Specifications for Electrical Installations and Supplements

Errata and Revisions

September 2010

Electric System Bulletin 750 Series

FIGURE 11: TYPICAL MANHOLE REQUIREMENTS

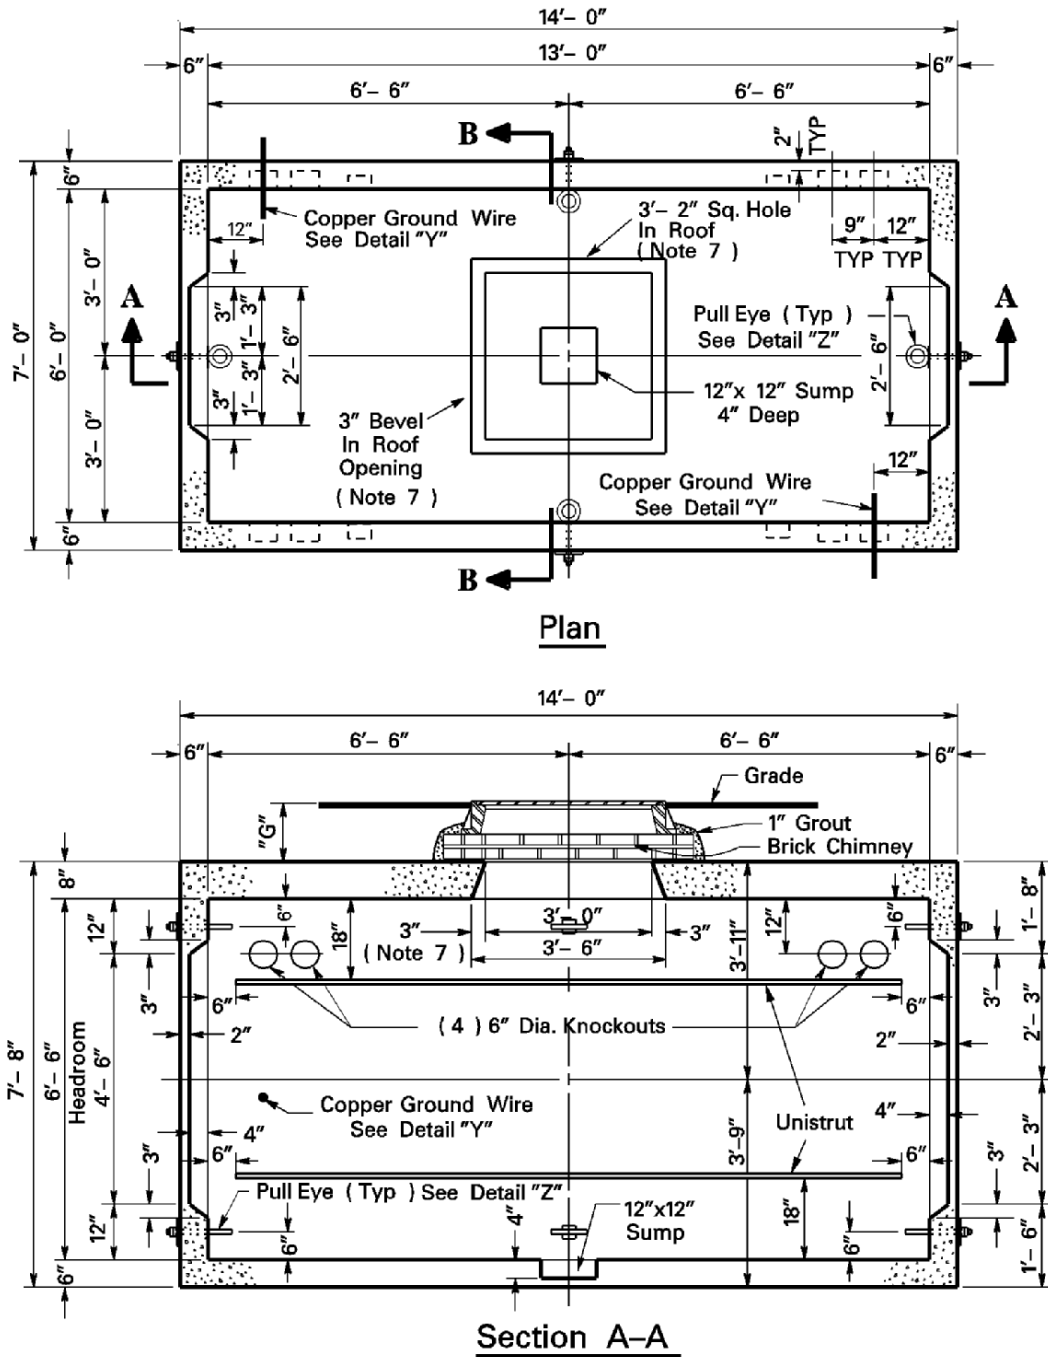
31	Figure 11	Sep-2010	Replace typical manhole requirements drawing with updated ground wire; see * below.
32	Figure 11 (cont'd)	Sep-2010	Replace typical manhole requirements continuation drawing with updated proper ground wire and detail Y; see * below.

Figure M-1 – Typical Primary Switchgear Metering Transformer Compartment Clearances

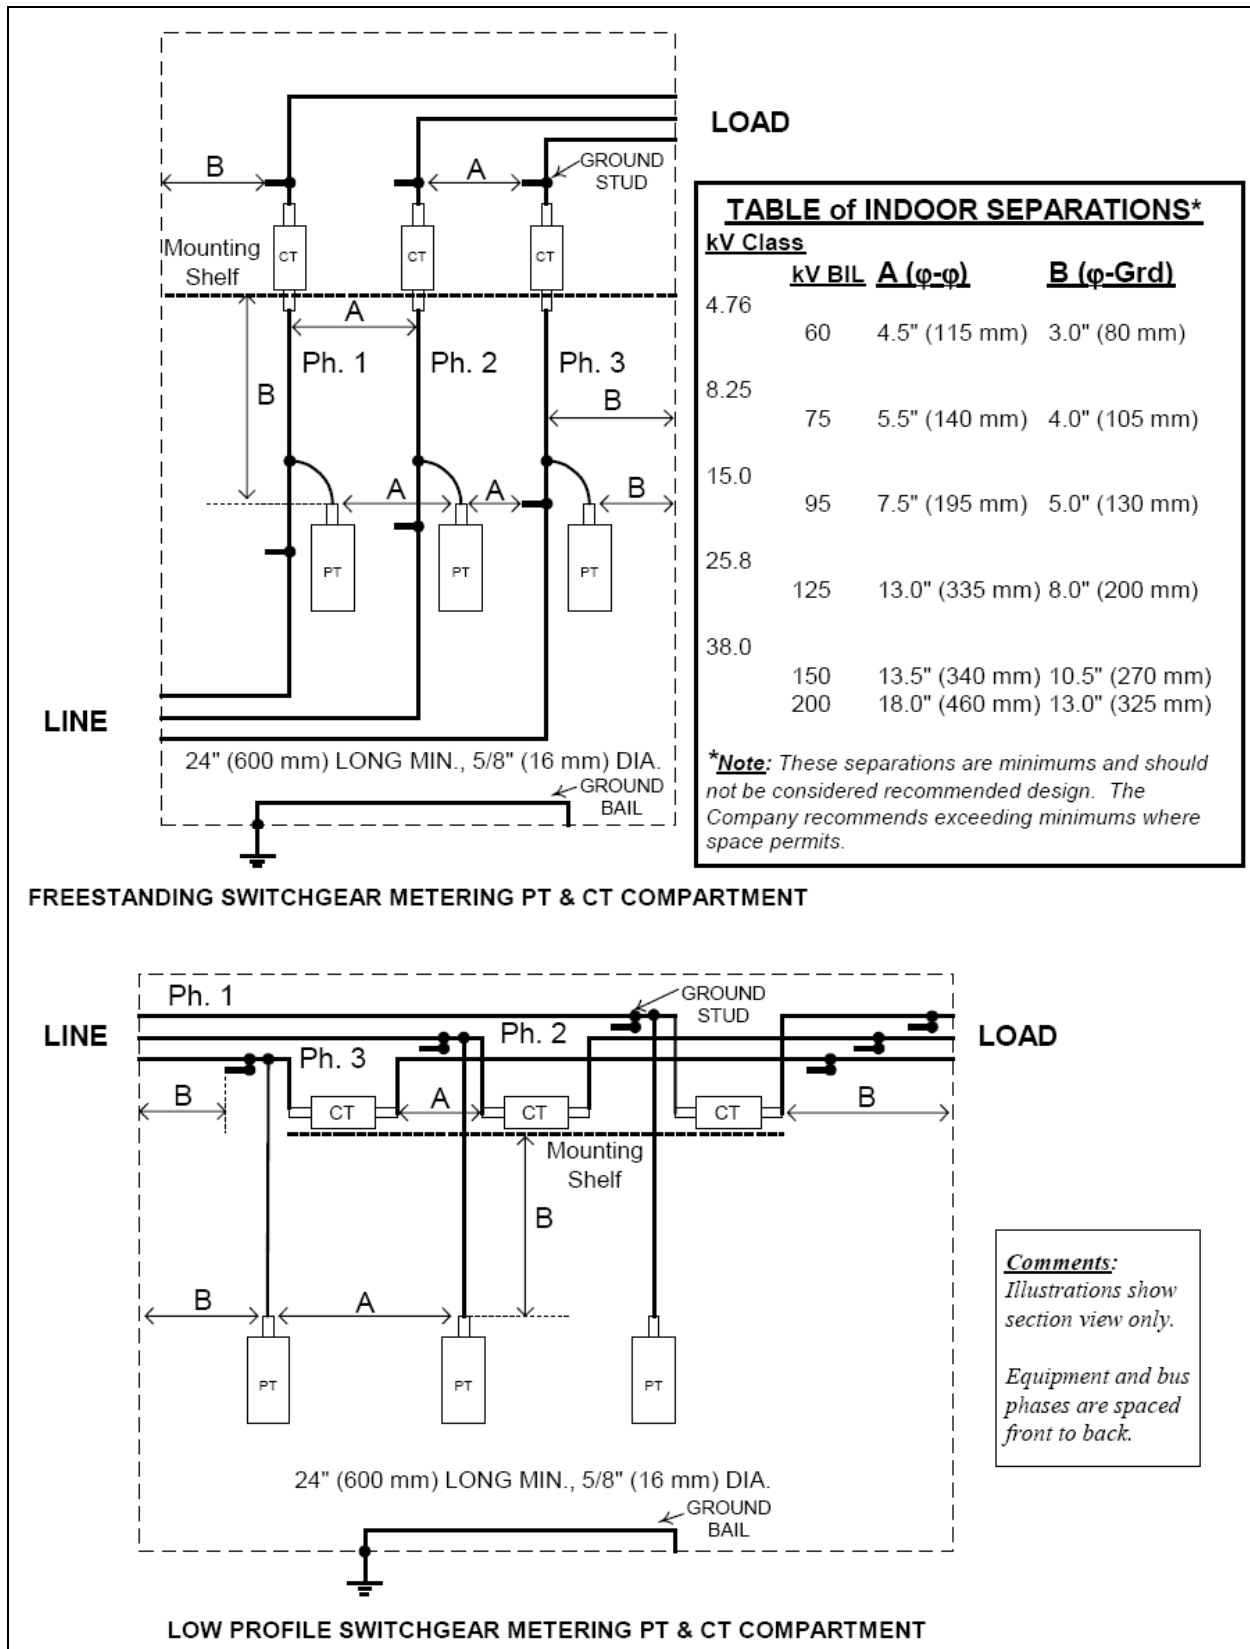
PAGE	SECTION	EFFECTIVE DATE	CHANGE
2	C Paragraph 11	Nov-1999	Delete the Inspection part in its entirety.
3	H	Nov-1999	Delete Paragraphs 18 through 20 and Paragraph 22.
4 and 5	I	Nov-1999	Delete Paragraphs 23 through 26.
5	J Paragraph 28	Nov-1999	In the first sentence, change “outdoor” to “indoor”.
8 - 10	M	Sep-2010	Change this metering section in its entirety and replace it with the new information ** below.
Fig. 1	Note #3	Apr-2002	In Note 3, change “see Paragraph 18” to “see ESB 750 Section 4”.
Fig. 1	Note #4 (new)	Sep-2010	Add new note: “Note #4: The clearances shown from the front of the service equipment to a building wall and from the rear of the service equipment to a building wall shall be both 10 foot (minimum) if the switchgear is designed with the Company required access to the incoming termination compartment on one side while the metering PT/CT compartment is on the other side; see Figure 1A. Otherwise, if the Company’s access to both compartments is on the same side, then the other side’s clearance can be reduced to the clearances presently shown.” Add new Figure 1A ** below.

- d. The entire metering compartment shall be designed and constructed with adequate ventilation.
- e. The minimum width of the metering transformer compartment must be based on the electrical clearances of Figure M-1. The Customer shall maintain a minimum 10 ft. (3.0 m) unobstructed clearance in front of the metering transformer compartment access door.

- k. The metering transformer compartment shall be solely accessible by the Company. This requires section-to-section openings for through bus to be maintained as small as phase to ground clearances in Figure M-1 will allow.

- l. Where the clearances in Figure M-1 cannot be provided, Glastic (NEMA Type GPO 3 material) barriers are required between potential transformers and between potential transformers and the enclosure walls.
